Recommended Howard Avenue Alternative:

Reimagine West Howard Avenue

Atlanta Avenue RR Crossing Improvements Traffic Calming and West Howard Avenue Refined December 9, 2020

Reimagine West Howard Ave – The Sequel Workshop #1

Existing with Striping (Alts #1&2)

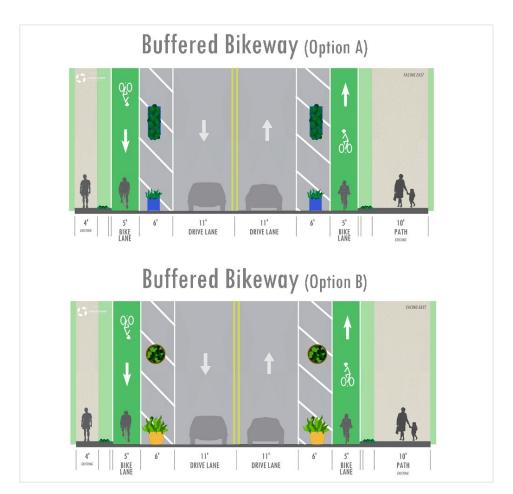
- Maintains existing configuration of roadway
- ✓ Terracotta planters may create a "softer" character than existing bold-colored planters
- ✓ Maintains parking on north

(westbound) side of Howard Ave

Disadvantages

- Retains "temporary" feel
- Does not designate street space for bikes

Buffered Bikeways (Alts #3&4)

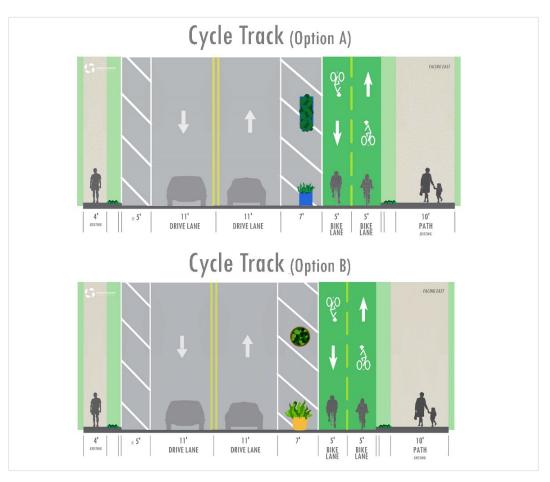
- ✓ Provides designated space for bikes on street
- ✓ Moves higher speed cyclists off the path
- Provides more space and comfort for path users
- ✓ More definitively narrows roadway than facilities on one side of Howard Ave

Disadvantages

- Eliminates all parking on north side of Howard Ave
- Portable planters may not provide high level of perceived separation for cyclists
- Requires westbound bicyclists using the PATH to cross Howard to access WB bike lane
- Frequent driveway interference on north side

Cycle Track with Striping (Alts #5&6)

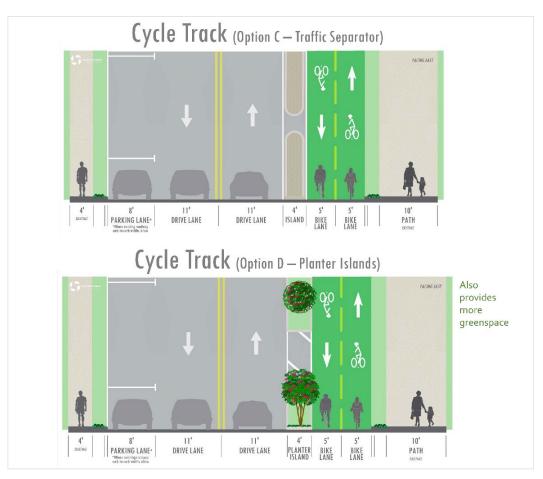
- Provides designated space for bikes on street
- ✓ Moves higher speed cyclists off the path
- ✓ Provides more space and comfort for path users
- ✓ Retains parking on north (westbound) side of Howard Ave

Disadvantages

Portable planters may not provide high level of perceived separation for cyclists

Cycle Track with Traffic Separator (Alts #7&8)

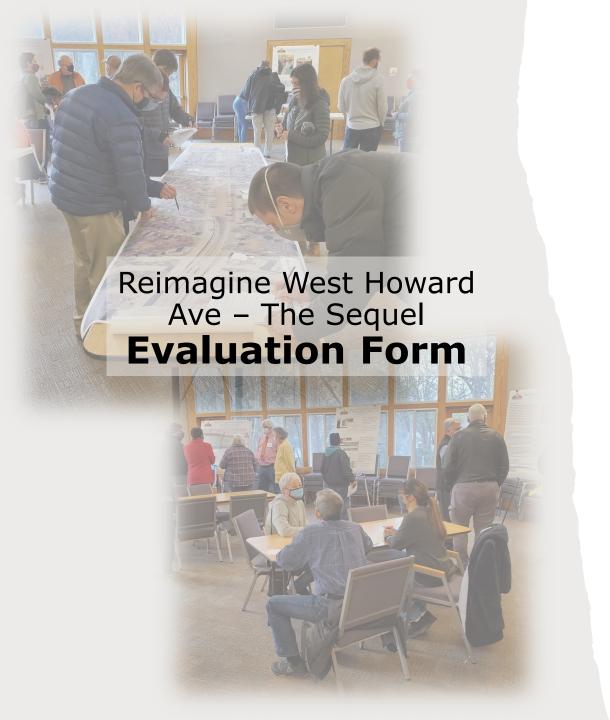
- ✓ Provides designated space for bikes on street
- ✓ Moves higher speed cyclists off the path
- ✓ Provides more space and comfort for path users
- ✓ Provides more positive narrowing of roadway compared to planter boxes or pots
- ✓ Retains parking on north (westbound) side of Howard Ave

Disadvantages

Somewhat reduced alternatives for access to and across Howard Ave for cyclists compared to planter boxes or pots
